# Access Compliance Report

## Public Rights-of-Way

Intersection ID: 10825	Main Street: E_26TH_ST	Cross Street: N_DAVIDSON_ST	Location:	N
ADA ID: 4D44D657AB1B	Ramp Type: Perp	Initial Pass/Fail: Fail	Overall Compliance: No	Severity Score: 10

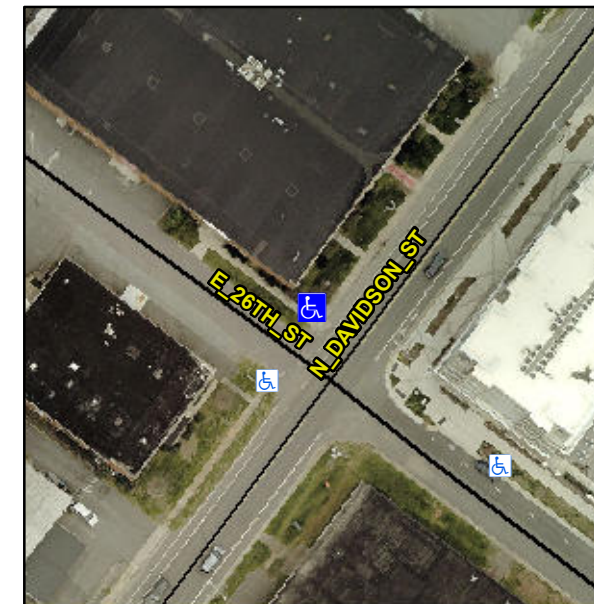
**Not Found, R304.5.1, R304.5.3**

Compliance	Description	Data	Compliance	Description	Data
N/A	Ramp Length (in)	79.0	Yes	Ramp Slope (%)	6.1
No	Ramp Width (in)	42.0	No	Ramp XSlope (%)	4.4
N/A	Flare Type LT	N/A	N/A	Flare Type RT	N/A
N/A	Flare Slope LT (%)	N/A	N/A	Flare Slope RT (%)	N/A
N/A	Flare Traversable LT?	N/A	N/A	Flare Traversable RT?	N/A
N/A	Landing Length (in)	N/A	N/A	DWS Provided?	N/A
N/A	Landing Width (in)	N/A	N/A	DWS Contrast?	N/A
N/A	Landing Slope (%)	N/A	N/A	DWS Length (in)	N/A
N/A	Landing X Slope (%)	N/A	N/A	DWS Full Width?	N/A
N/A	Landing Curb? (Y/N)	N/A	N/A	DWS Offset (in)	N/A
N/A	Shared Landing?	N/A			
N/A	Gutter Ponding?	N/A	N/A	Gutter Slope (%)	N/A
N/A	Gutter Lip Ht (in)	N/A	N/A	Gutter X Slope (%)	N/A
N/A	Painted X Walk1?	No	N/A	Painted X Walk2?	N/A
	X Walk 1 Direction	To SW		X Walk 2 Direction	N/A
N/A	X Walk 1 Width (in)	N/A	N/A	X Walk 2 Width (in)	N/A
	X Walk 1 Slope (%)	3.6		X Walk 2 Slope (%)	N/A
	X Walk 1 X Slope (%)	1.8		X Walk 2 X Slope (%)	N/A

**Remove & Replace Entire Ramp.**
